SK-RFI3204-E101A/186A

REQUEST FOR INFORMATION NOT ADDRESSED IN THIS CCO REMAIN IN FORCE

SAS SUPERSTRUCTURE AND SKYWAY STRUCTURE
GIRDER INTERFACE WESTBOUND
AS NOTED

SK-RFI3204-E132A/221A

E-101A

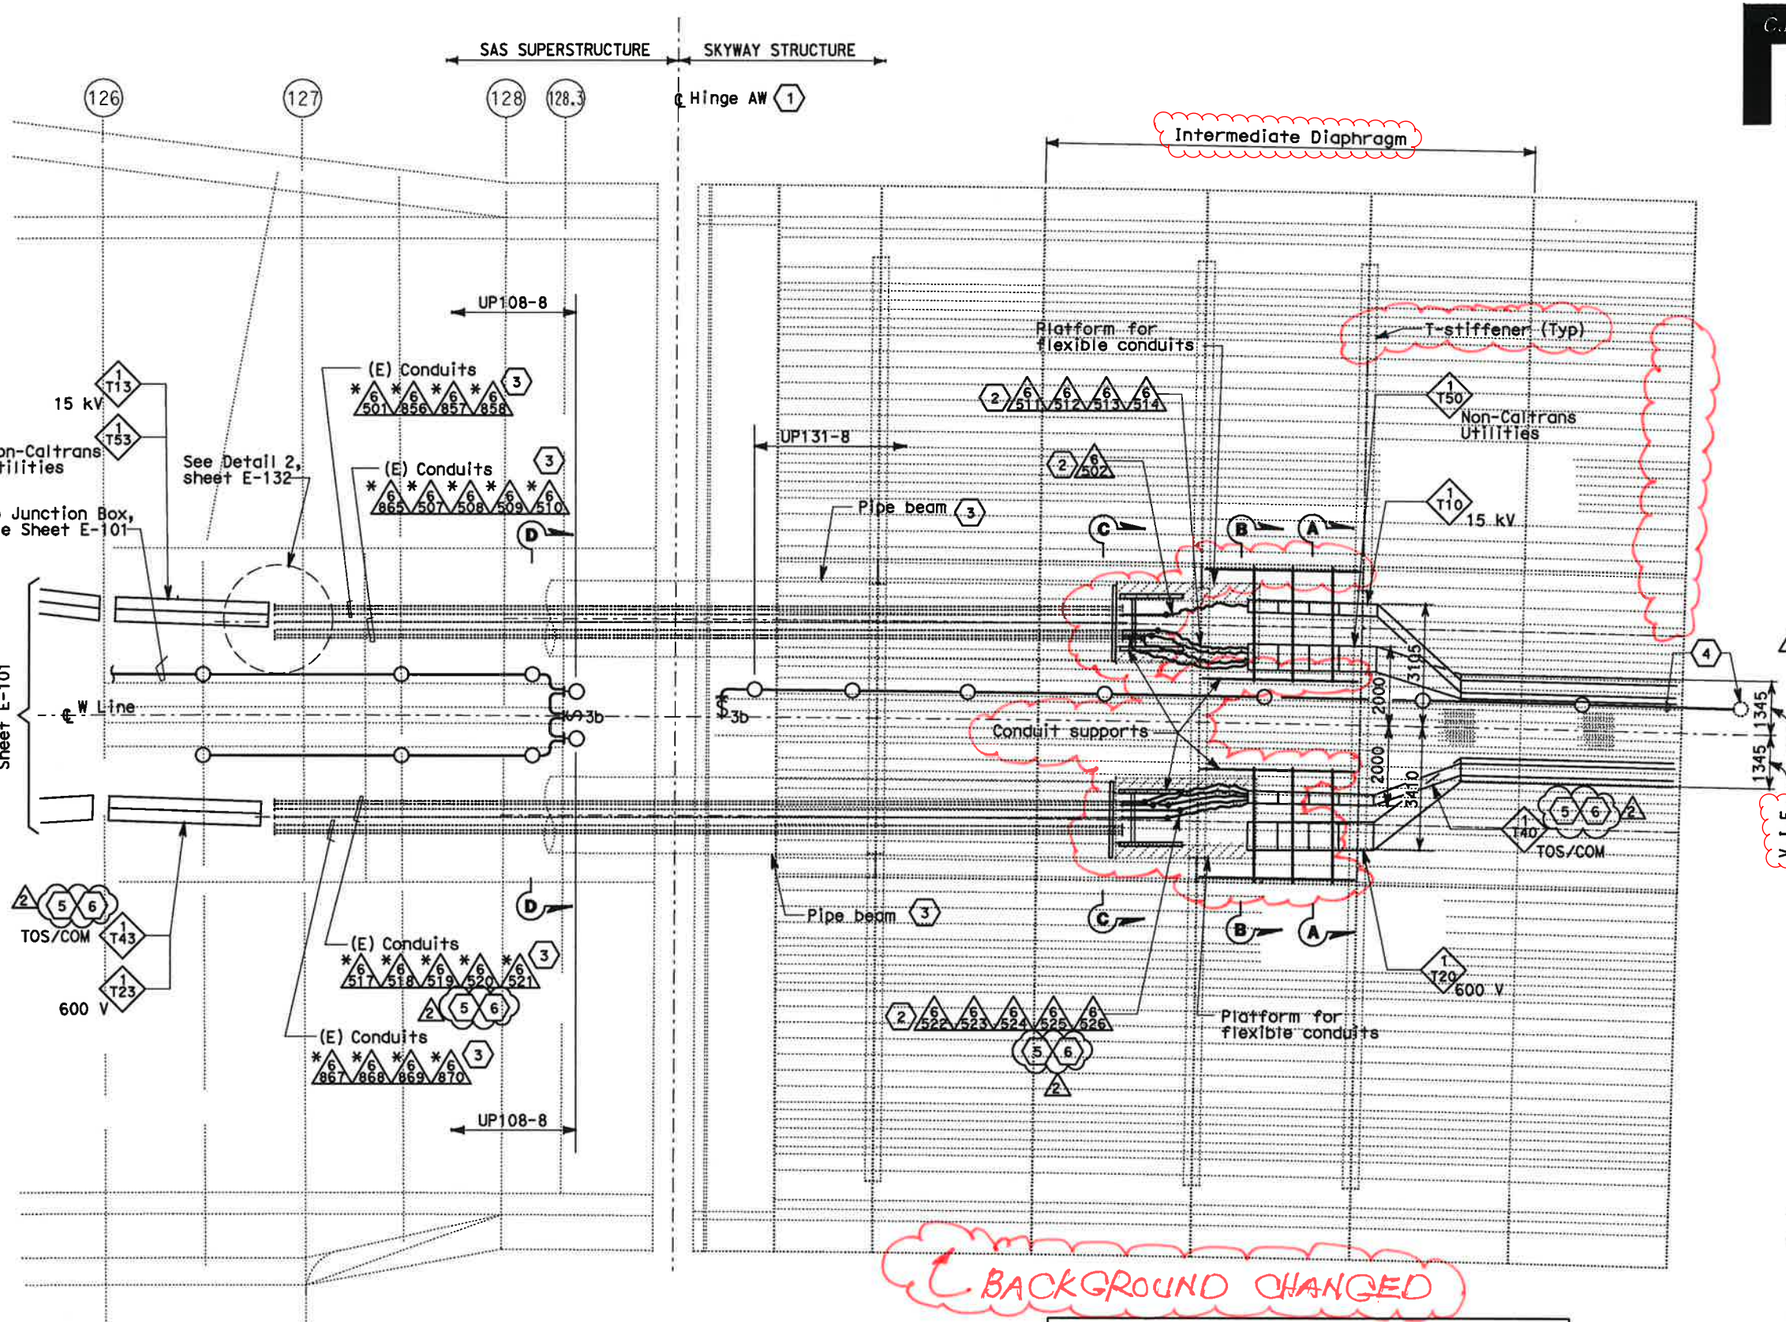
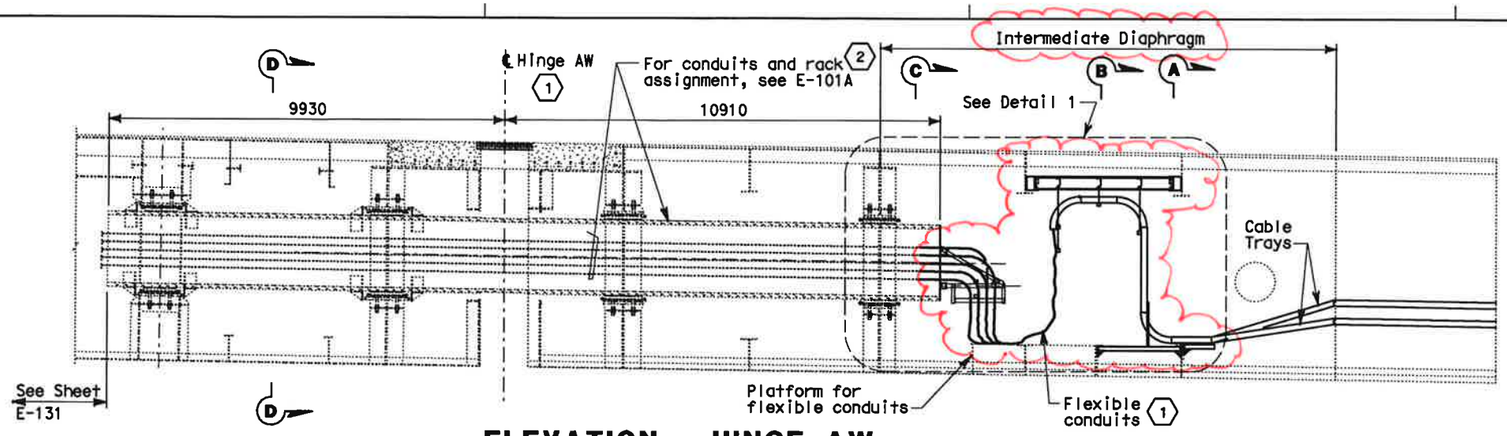
1. Hinge AW electrical design is based on the maximum expansion joint movement opening of 1243 mm.
2. Arrange and group the flexible 103 mm conduits to maintain a minimum voltage level separation of 460 mm between systems.
3. Existing conduits (*) inside pipe beam are supplied in Skyway contract.
4. Terminate conduit to the next lighting fixture and splice wiring to circuit UP131-8 of Skyway Structure. Contractor to adjust as required.
5. Furnish and install 4-25.4 mm innerducts inside TOS/COM conduits (*6520, 6525) and 1-25.4 mm innerduct per BASE fiber optic cable in TOS/COM cable tray.
6. Furnish and install BASE fiber optic cable in innerduct inside TOS/COM conduit and cable tray. See sheet E-1100.

E-132C

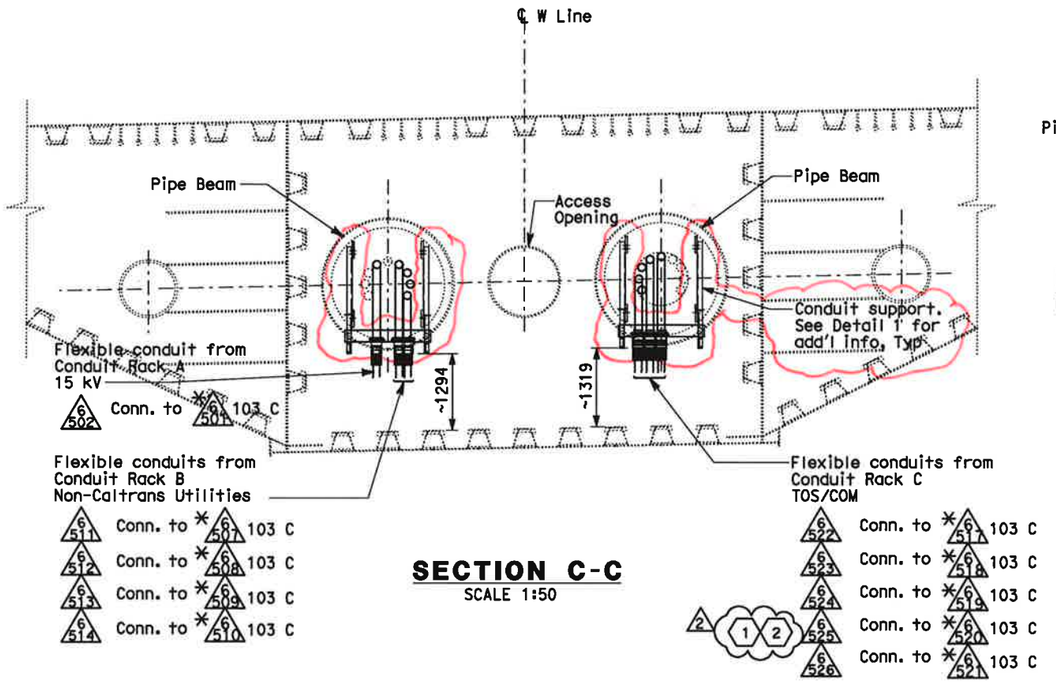
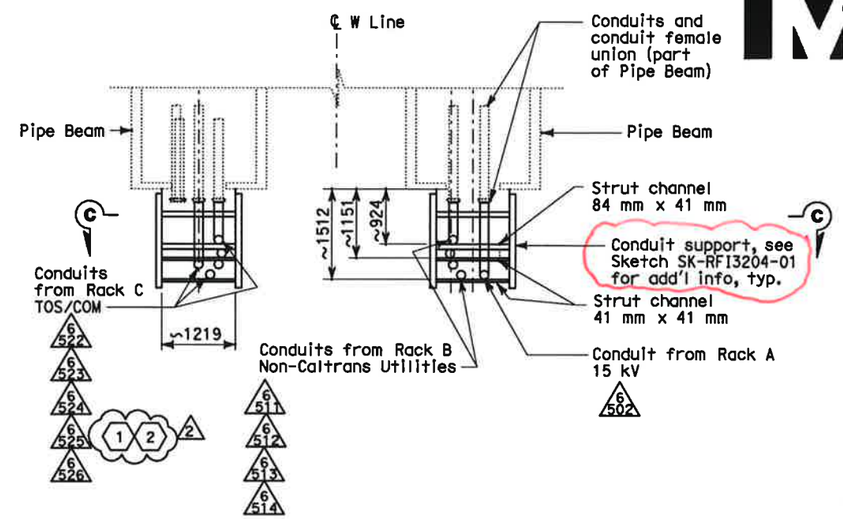
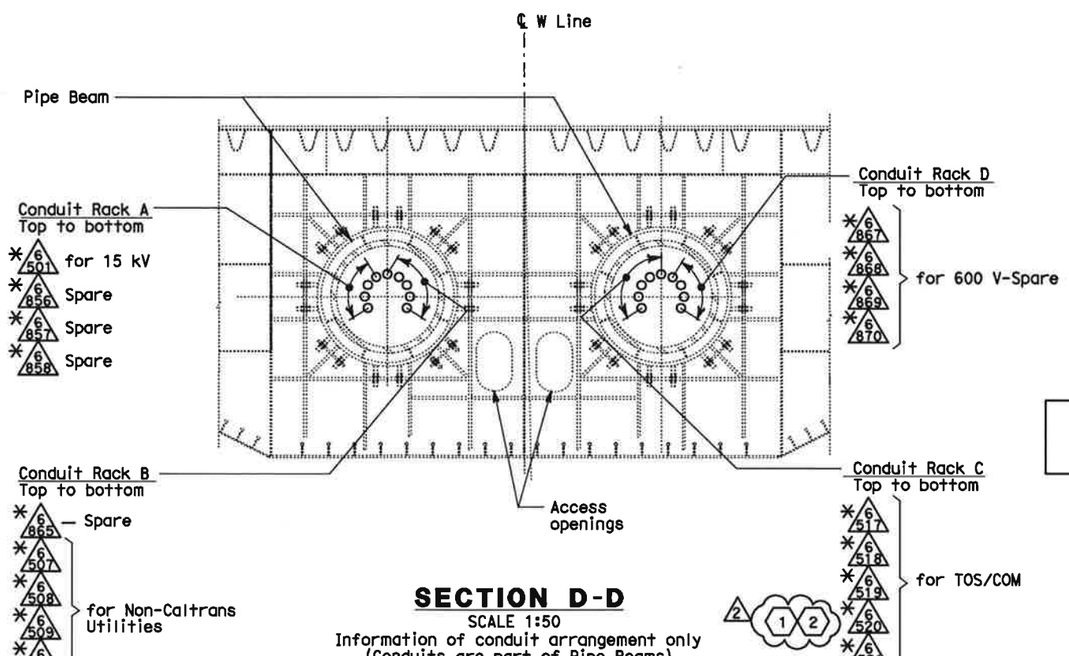
2 1 Furnish and install 4-25.4 mm innerducts inside TOS/COM conduits (*6520, 6525) and 1-25.4 mm innerduct per BASE fiber optic cable in TOS/COM cable tray.

2 Furnish and install BASE fiber optic cable in innerduct inside TOS/COM conduit and cable tray. See sheet E-1100.

SK-RFI3204-01

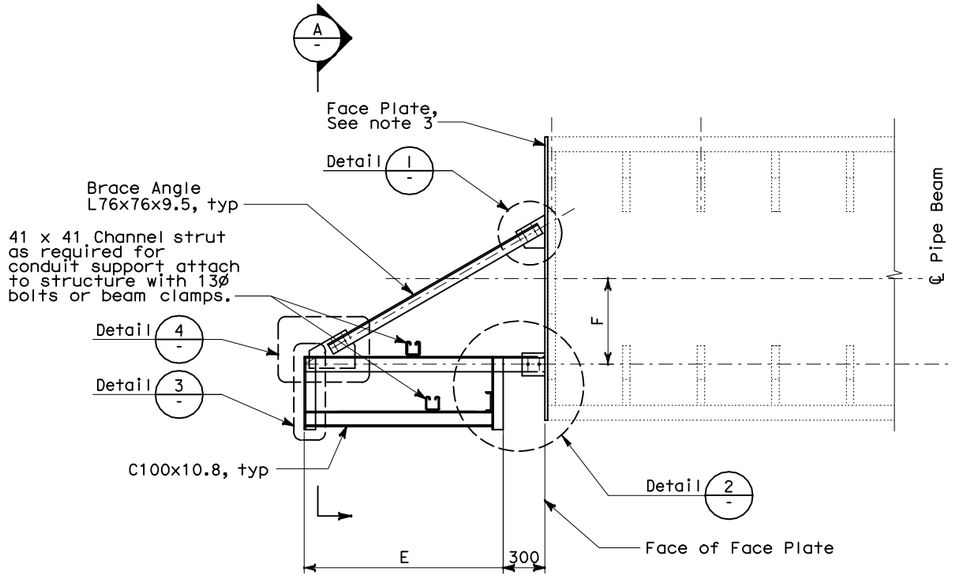
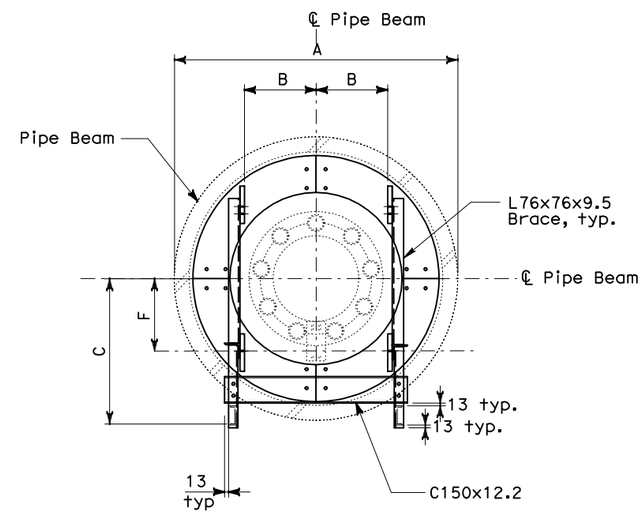
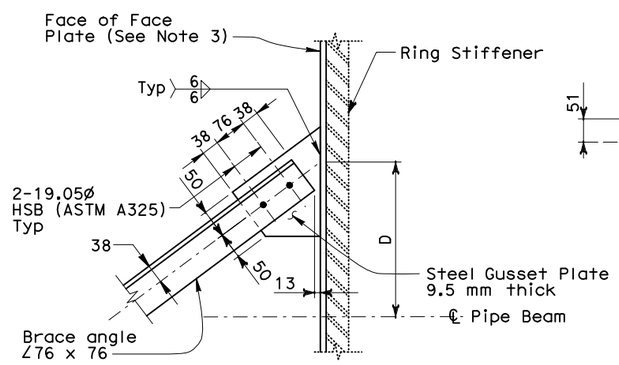
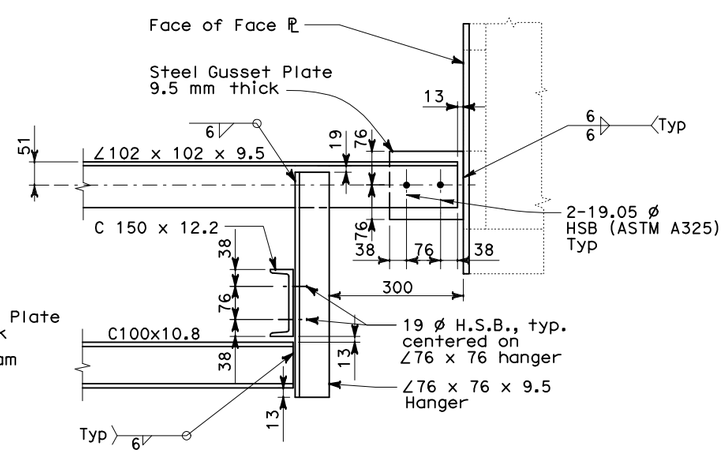
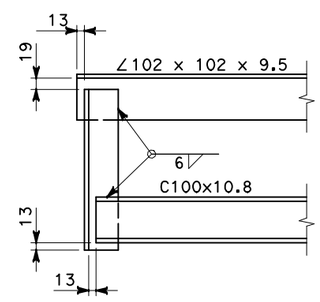
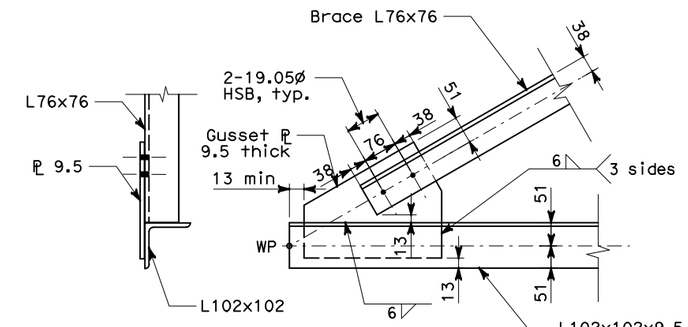
1. For General Structural Notes, see AS-1.
2. For other details not shown, see electrical plans.
3. See Sketch SK-RFI3204-2 for face plate.

SK-RFI3204-02

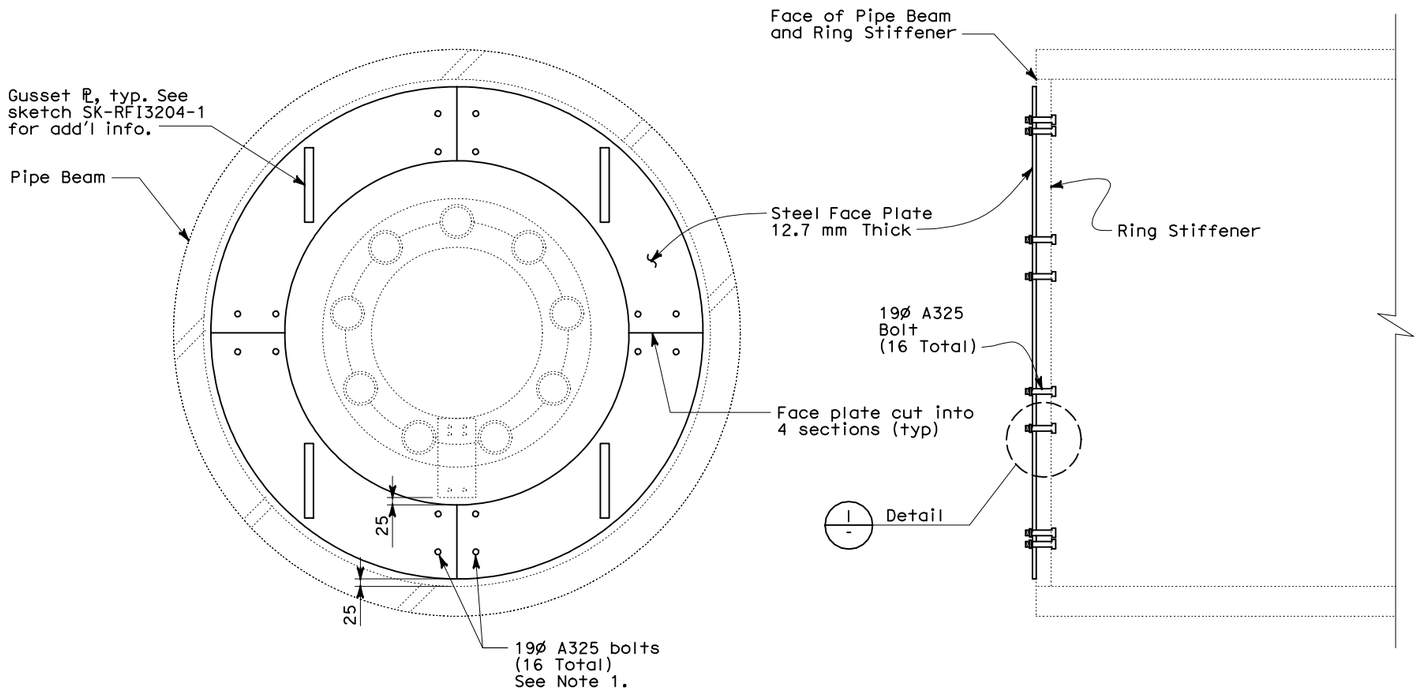
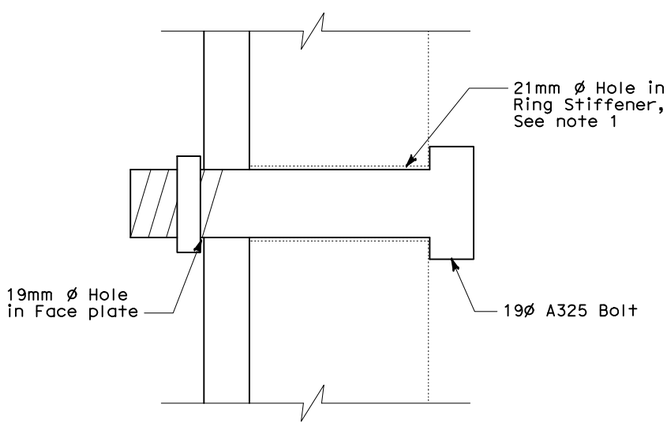
1. Bolt locations in face plate shall match existing bolt pattern in ring stiffener as shown. Verify existing bolt holes sizes in field.
2. Bolts shall be installed with lock washer.
3. All structural steel shall be hot-dipped galvanized.

SK-RFI3204-03

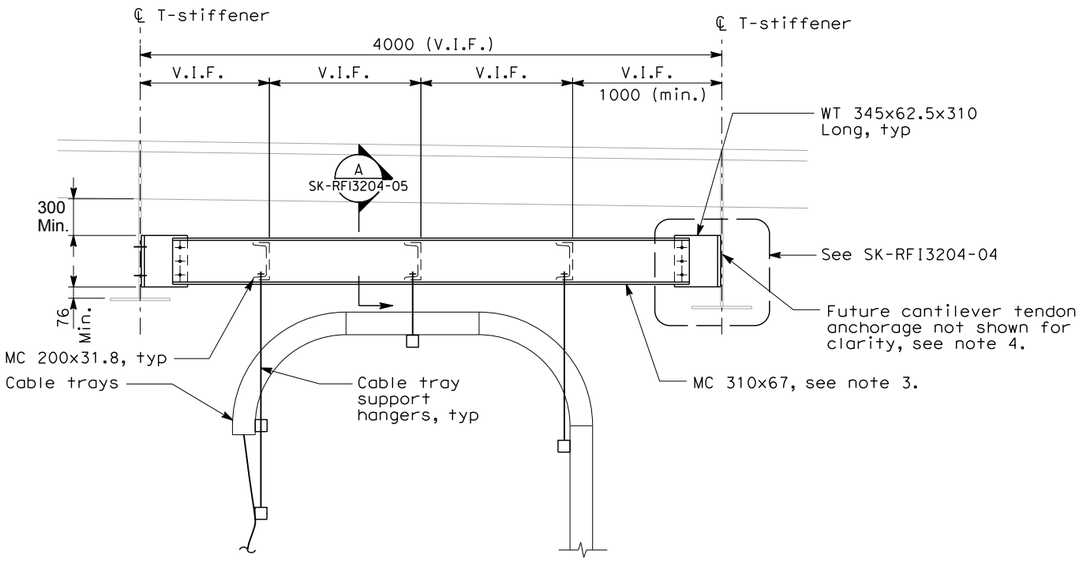
1. For General Structural Notes, see AS-1.
2. For other details not shown, see electrical plans.
3. MC channel shall be installed in true horizontal position.
4. Contractor shall maintain 305 min. clr. in all directions around future tendon anchorage zone.
